SERVICE BULLETIN

N° 139-543

DATE: February 3, 2021

ATA 71 – TUNNEL ASSY AND FIREWALLS RETROMOD

Figure 8

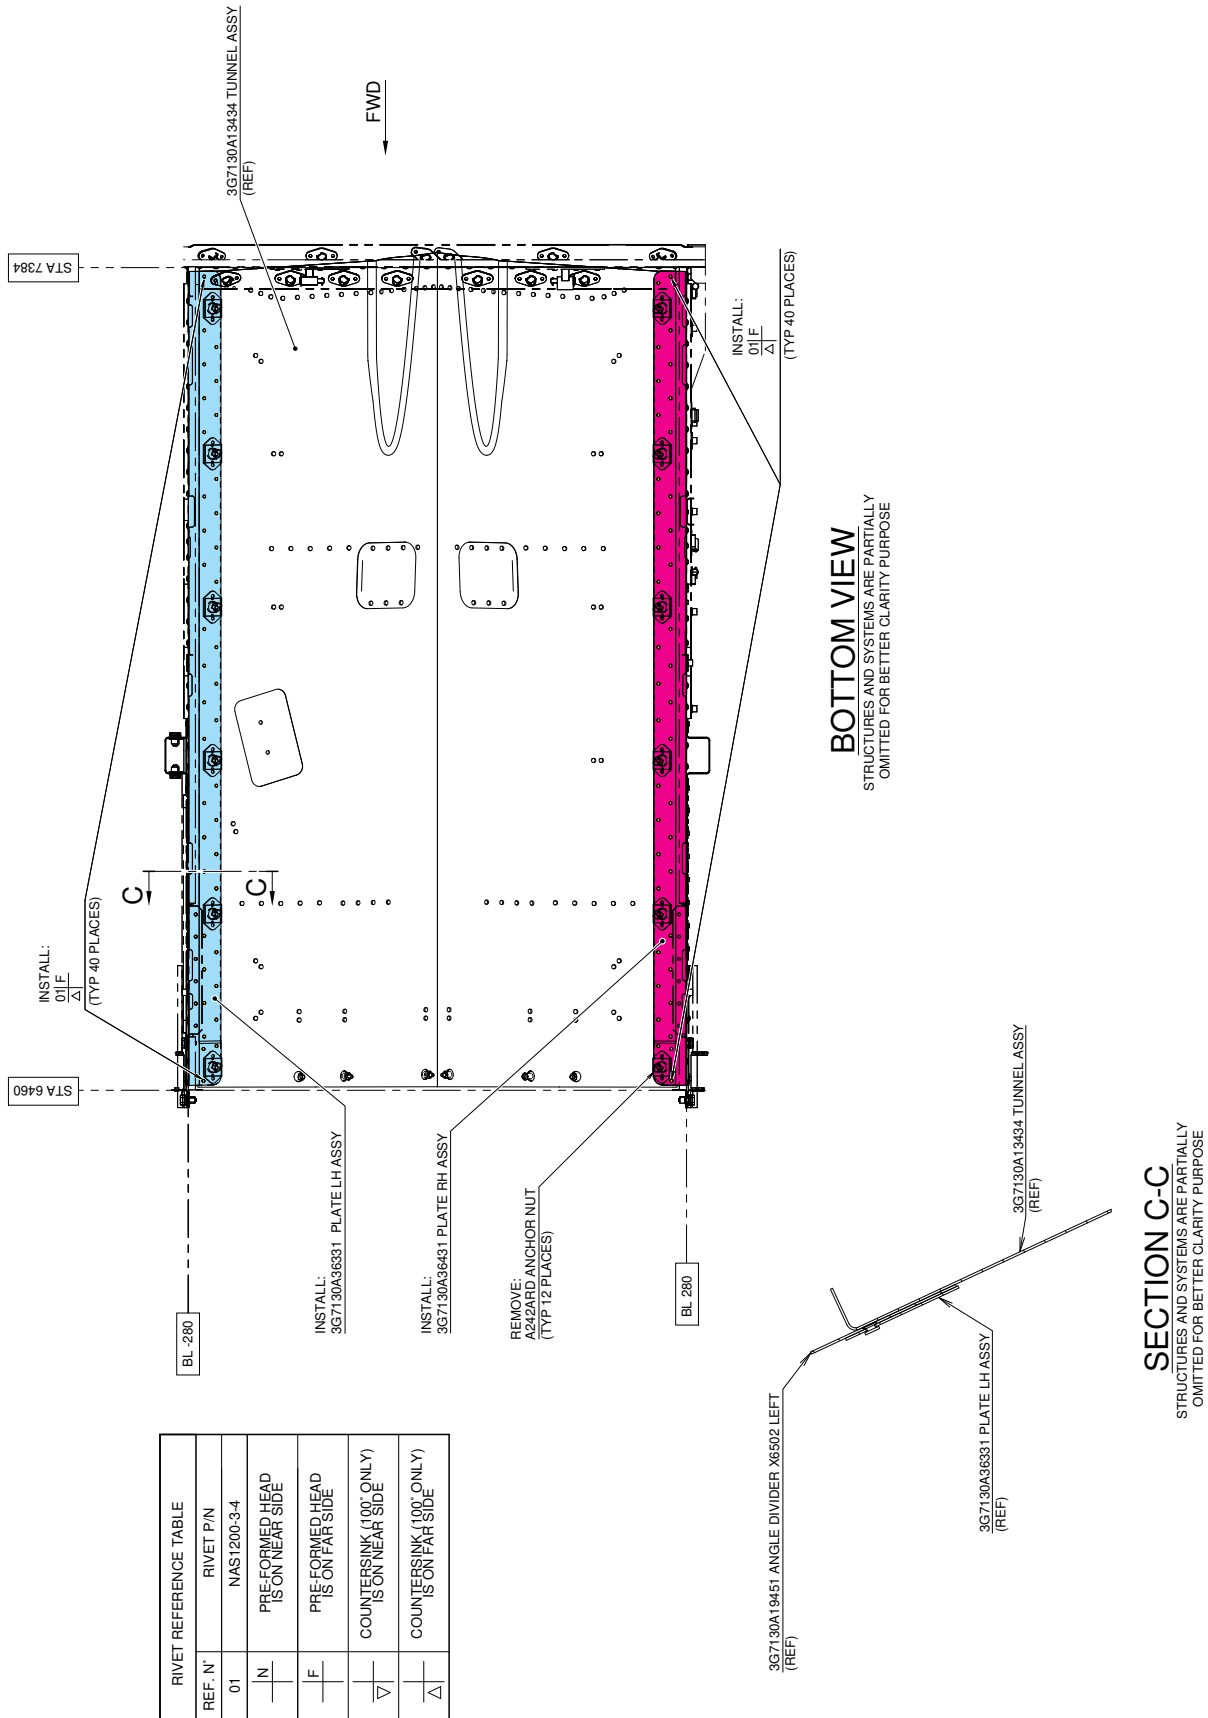
7. With reference to Figure 6, remove and discard the tunnel assy P/N 3G7130A13431 from the helicopter, unlocking the related turn locks.
8. With reference to Figure 8, remove and discard n°12 anchor nuts P/N A242ARD.

Figure 9

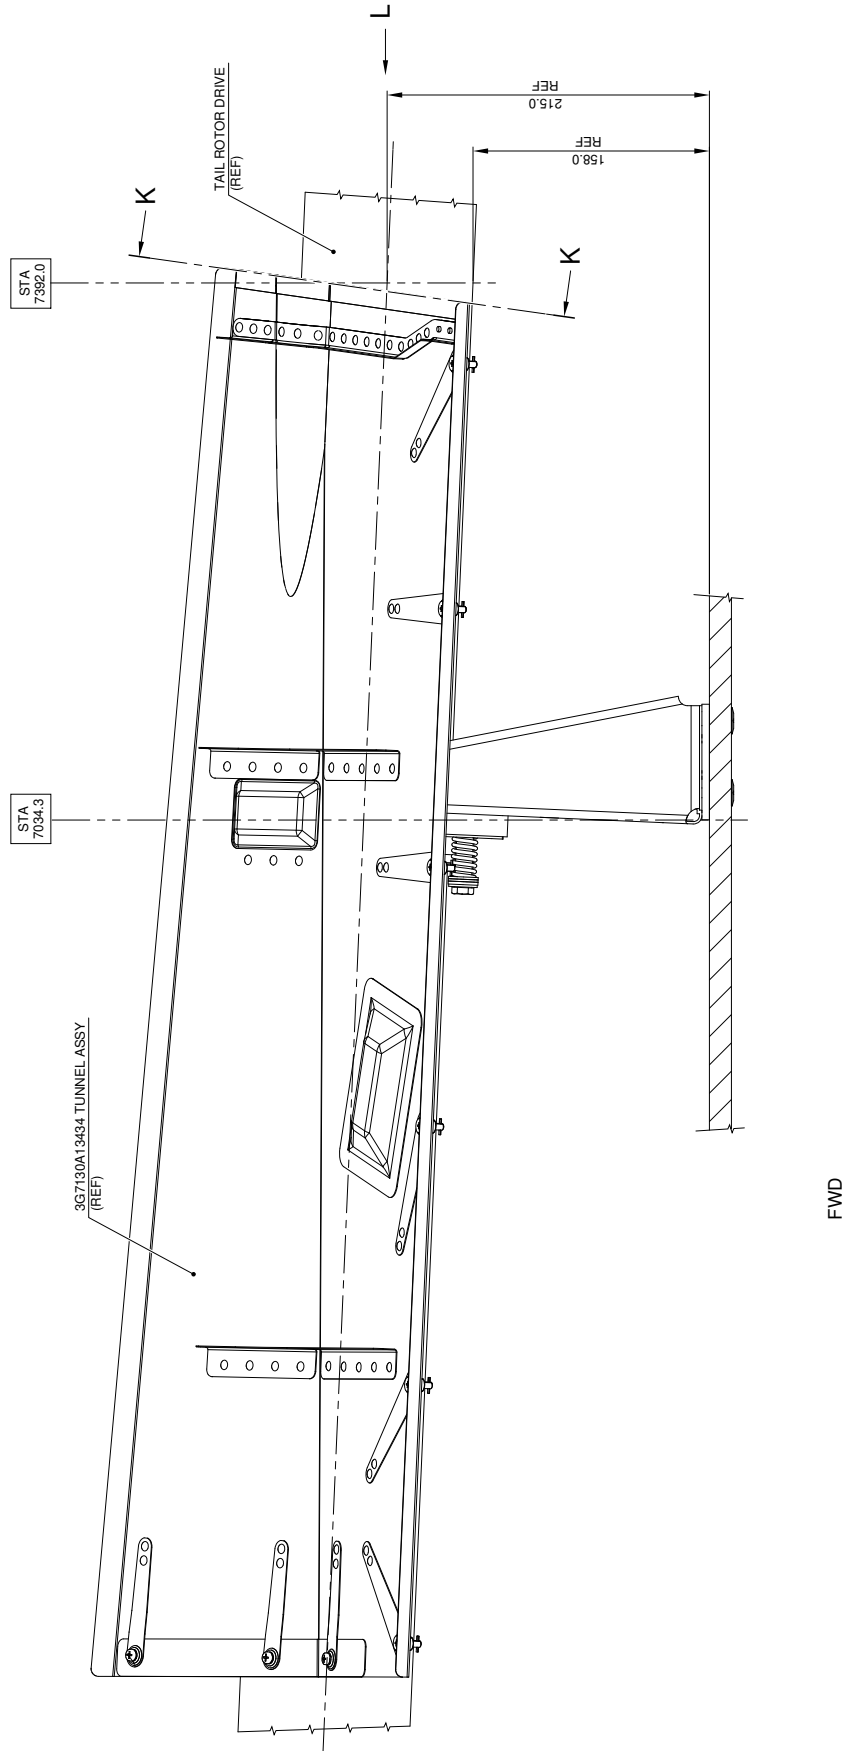
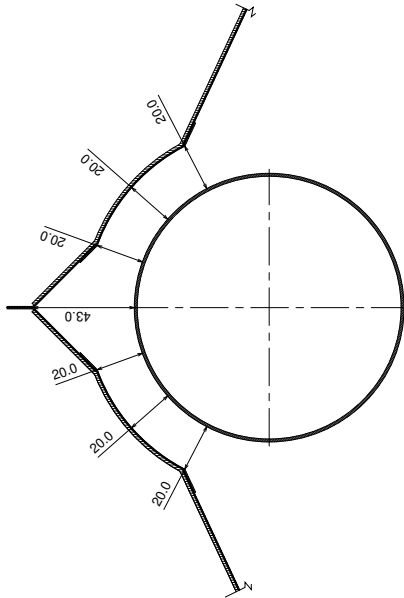
- 13.2 With reference to Figures 9 View J and Figure 10 View L and Detail M, check the positions of the tunnel assy and the tail rotor drive as indicated. The allowed tolerance is +/- 2 mm. Go to step 13.1.

Figure 10

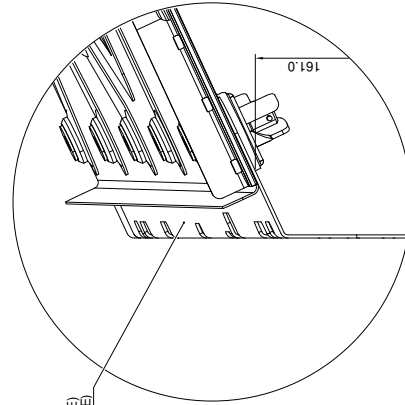
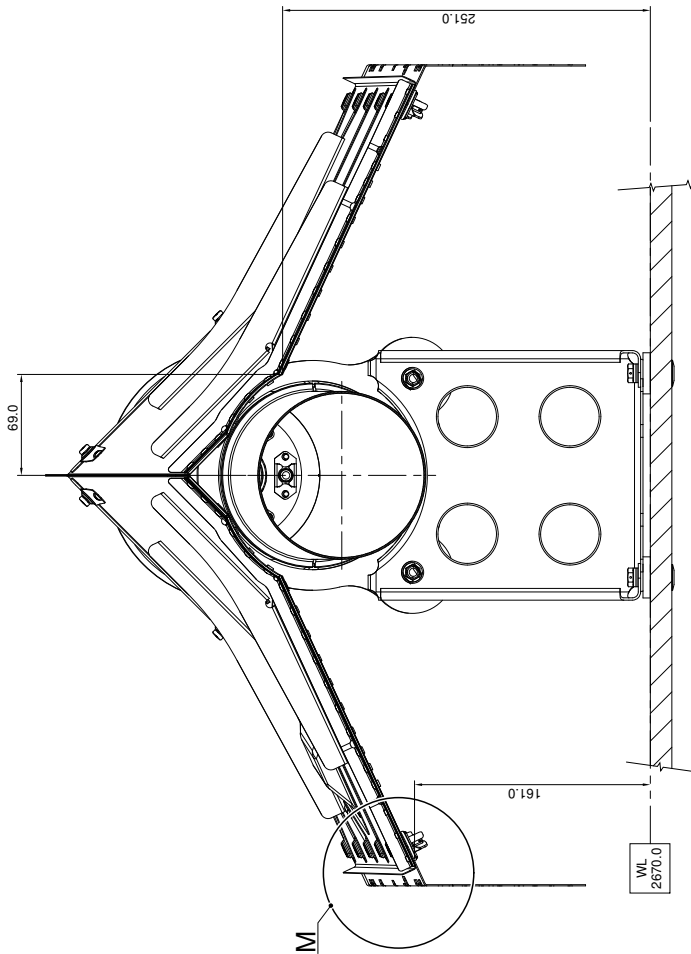
The dimensions reported in Figures 11 Section K-K represent nominal clearances and are mandatory.

- 13.1 With reference to Figures 10 Section K-K, check the clearance between tunnel assy and tail rotor drive as indicated. If the minimum clearances are not met continue to the following step, otherwise skip to step 14.
